FIRE SAFETY INSPECTION REPORT

Occupant Name:	Heron Pond - Maintenance	Inspection Date:	1/19/2023
Address:	8300 Southwest 5 Street	Inspected By:	Victor Santos
Suite:		Property Use Type:	Residential/Pool Cabana
Occupant Number:		InspectionType:	Annual Fire Alarm (FAS), Annual Fire and Life Safety Inspection
Occ. Sq. Ft.:	1300	Number of AEDs:	0

1.1 - 10.1.4.1.

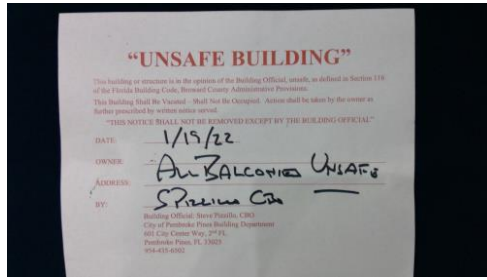
Deficiency		FL NFPA 01 2018 Chapter 10 General Safety Requirements	10.1.4.1 - Excerpt: Where structural elements have visible damage, the AHJ shall... (see photo 1.1)
-------------------	--	--	---

Inspector Comments: ***The noted structural damages have been referred to the City's Building Official and Structural Chief for evaluation of possible unsafe conditions. A site visit with structural inspectors and the Building Official to demonstrate areas of concern was conducted. Following the site visit, an structural engineer was consulted and in conjunction with the Building Official, deemed each patio/balcony area unsafe. The Building Official instructed Xochitl Alvarez, the property manager, to produce an analysis and proposal completed by a structural engineer for conditions and repairs within 48 hours. Each building and unit had an "Unsafe Building" notice posted on the front door as well as verbally communicated with residents who were home at the time. Residents were instructed that due to the unsafe conditions, they are to remain clear of the patio/balcony area until further notice is given.***

Where structural elements have visible damage, the AHJ shall be permitted to require a technical analysis prepared in accordance with Section 1.15 to determine if repairs are necessary to restore structural integrity.
